SLBI Response to
Response to Public
Comment Document

Issues Remaining Regarding the EPA OCS CAA Permit Issuance to the Atlantic Shores South Offshore Wind Project, Permit # OCS-EP-R2 NJ 02.

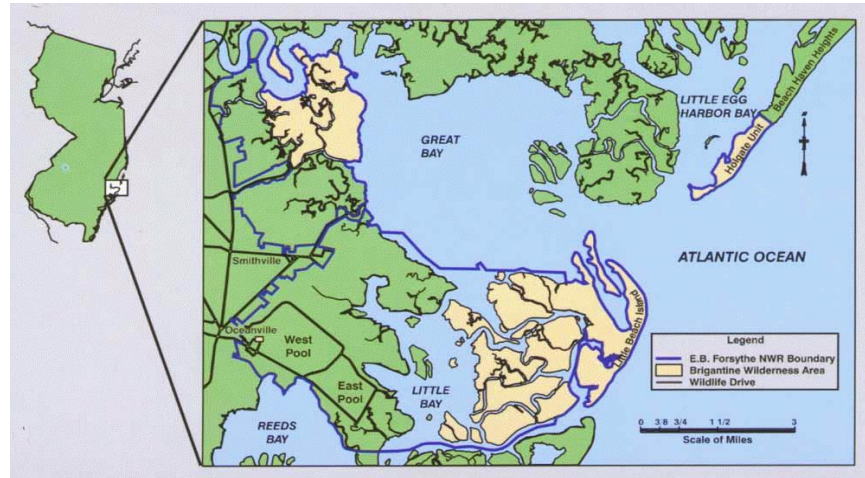
The Brigantine Wilderness Class 1 Area is shown below. This unique and valuable resource is the home and stop-over point for migratory birds and water fowl along the eastern coast of our

Our concern about the State Regional Haze Implementation Plan not being valid because it did not consider offshore particulate emissions was not addressed. Neither the EPA or the State addressed the issue that the NJ Regional Haze SIP needed to be revised because it does not account for the significant visibility impairments from OCS wind construction and from decommissioning in meeting the State's haze goals.

By approving this permit and allowing a significant adverse impact on the visibility in the Brigantine Wilderness Class 1 area from a source that was not included in the SIP, the EPA has invalidated the rate of progress measures and the SIP goals. This air permit should not have been granted pending revisions to the SIP to assure that additional offsetting emission reductions can be achieved so that the stated haze objectives can be met.

Figure 1

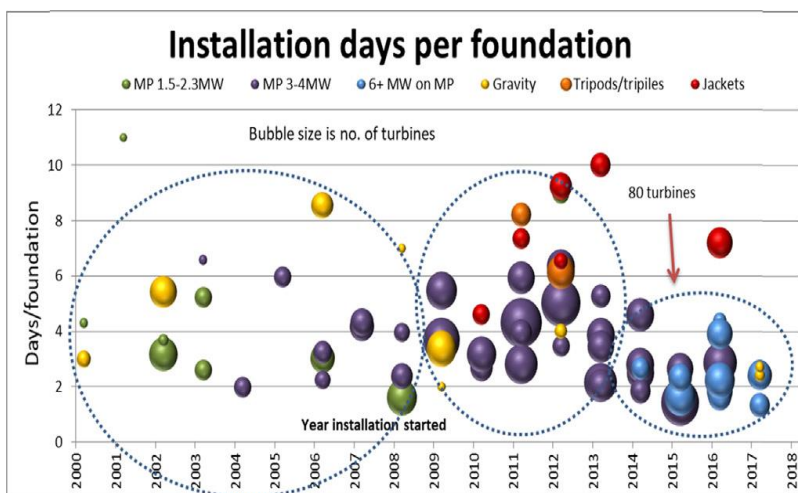
The latter estimates do not appear realistic. It logically takes more time to install the foundation than the WTG. The estimate of 1.5 days is not consistent with the real world data we provided in item 2 of our detailed comments and shown below for smaller 6 megawatt (MW) turbines. That data points to at least two days required per foundation installation for those turbines. That would be greater for the thicker shell foundations here for the 15 MW turbines as described in our comments.

The Epsilon Associates estimate of 2.6 days for foundation installation for the larger turbines here is therefore supported by real world experience with installation times as shown above for smaller turbines, and more realistic.
